SUBJECT: Response to Questions on C-E Heated Junction Thermocouple

Response to NRC Questions
on the C-E Heated Junction Thermocouple
System

FIGURE 1-3
EXPECTED EFFECT OF RCPs ON
HJTC MEASUREMENT FOR FULL LENGTH PROBE

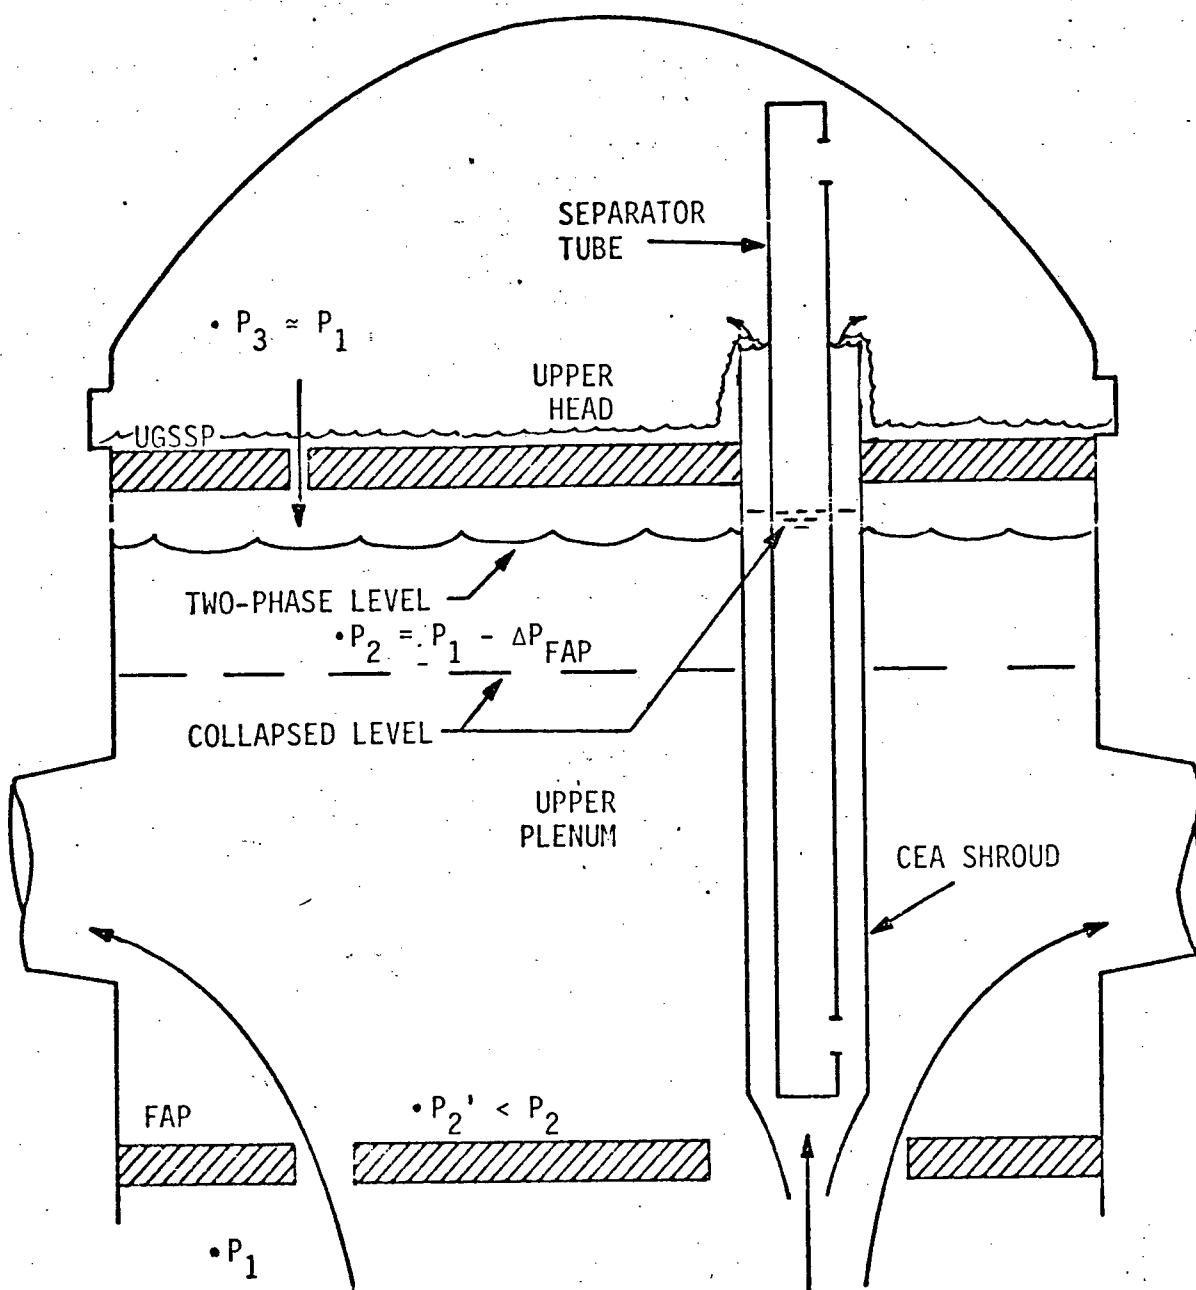
Provide an analysis of the response (with the reactor coolant pumps running) of the heated junction thermocouple level measurement system (a) with the full length separator tube, and (b) with the split separator tube in the System 80 plants. Also discuss the instructions to the operator for interpretation of the indications.

The effect of the RCPs on the measured collapsed water level is different for the two probe assembly installation designs. One design is a full length probe installed inside an empty CEA shroud, see Figure 1-3. For this installation the RCP operation has no effect on the HJTC measurement until after the collapsed water level drops below the top of the shroud (in this context, top of the CEA shroud actually refers to the large flow holes in the walls of the shroud which are located below the actual top of the shroud and above the UGSS-plate). The operating RCPs are expected to cause the collapsed level inside the CEA shroud to be higher than the collapsed level in the upper plenum. This is due to the lower pressure drop across the FAP for flow into the CEA shroud and upper head than for flow into the upper plenum. Thus, the RCPs are able to support a higher column of water inside the shrouds than outside in the upper plenum.

The HJTC probe will correctly indicate voiding in the upper head down to the elevation of the top of the CEA shrouds. The HJTC probe will also accurately measure the collapsed water level in the shrouds. However, it is expected that the measured collapsed level inside the shrouds will be higher than the collapsed level in the upper plenum.

For the full length probe it will be recommended that the operator should disregard the indicated level with the RCPs running after the level has dropped to the top of the CEA shroud and below. The placement of the HJTC sensors is such that one sensor per probe is located at the elevation of the top of the CEA shroud and one or more sensors above the top of the CEA shroud.

Figure 1-1
HEATER POWER CONTROL LOGIC (EACH CHANNEL)

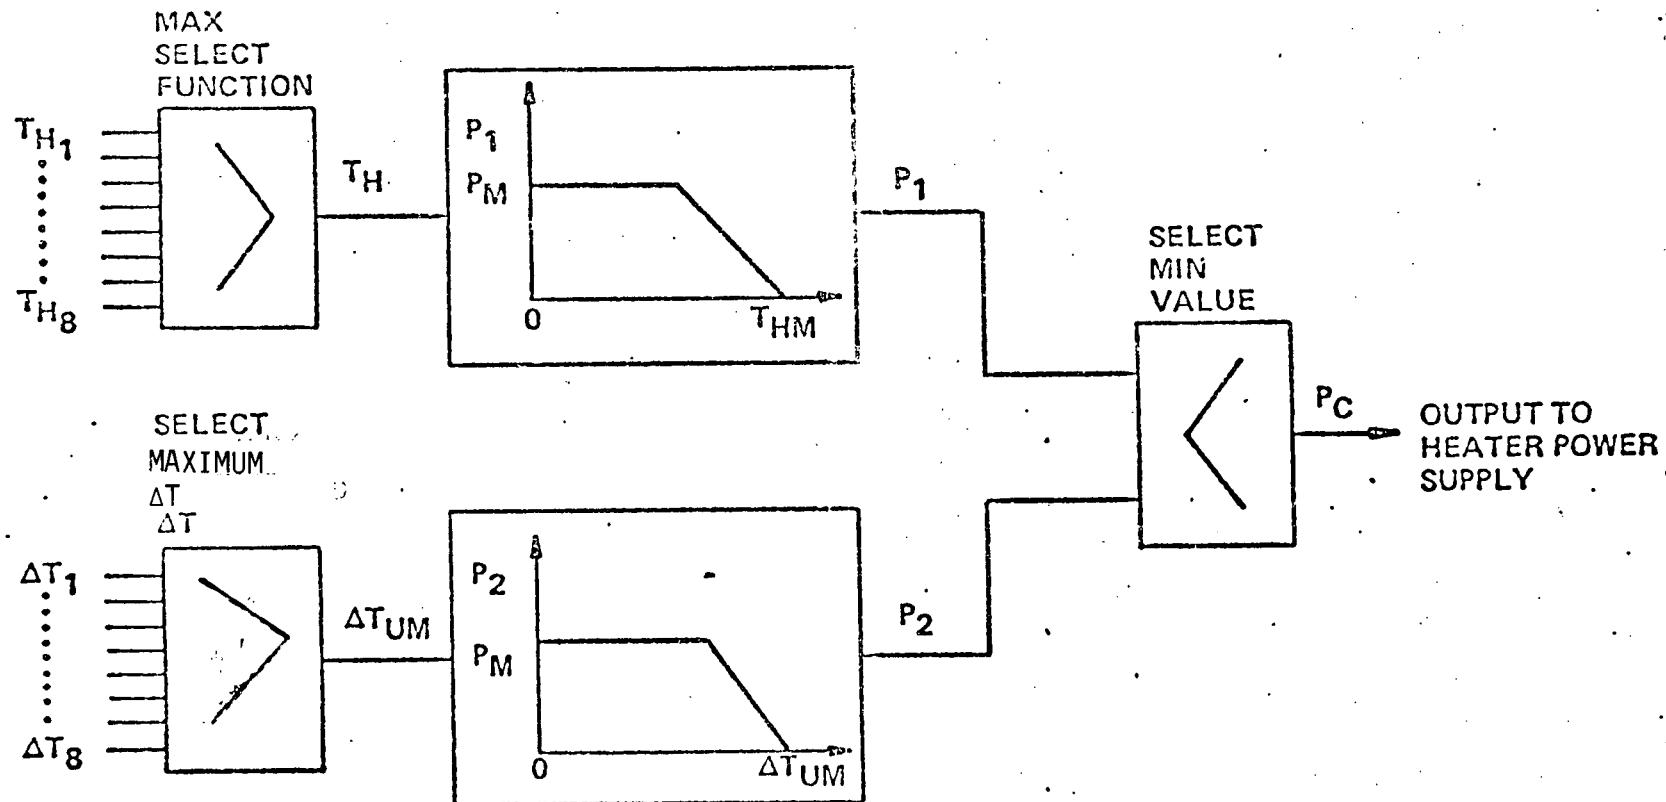
- 1) If the heater supply is designed for fast response, rapid fluctuations in the control signal can induce oscillations in the heater supply output. This in turn could cause heater failure by overheating or fatigue.

The heater controller used in the RVLMS is a time modulated controller. When the control signal from the processor calls for full power, the controller delivers 100% power, 100% of the time. If the processor calls for 50% power (for example), the controller delivers 100% power for only one half of its duty cycle. The particular controllers utilized in the Heated Junction Thermocouple System have a duty cycle of 0.8 seconds. The sensor heaters and the controllers are sized such that full power is applied to all heaters during all normal operating conditions (i.e., when the sensors are covered, or at high pressure). In the event that uncovery occurs, the heater controllers may be called upon to reduce power to the heaters depending on the absolute temperature of any heated thermocouple or on the differential temperature of any sensor as shown in Figure 1.

The heater control scheme uses a proportional control law in which the microprocessor heater control signal goes from 100% to 0% over a temperature input range of 200°F. This shallow slope prevents large changes in power from being applied for small changes in input temperature. Some heater power cycling has been observed to occur because of the sampling rate of the microprocessor.

During Phase III tests of the system, the fluctuations of the heated junction temperature have been observed to be relatively small, on the order of 10°F. These fluctuations are insignificant when compared to the temperature swings which result from uncovery or quenching of the sensor, and do not contribute significantly to heater fatigue.
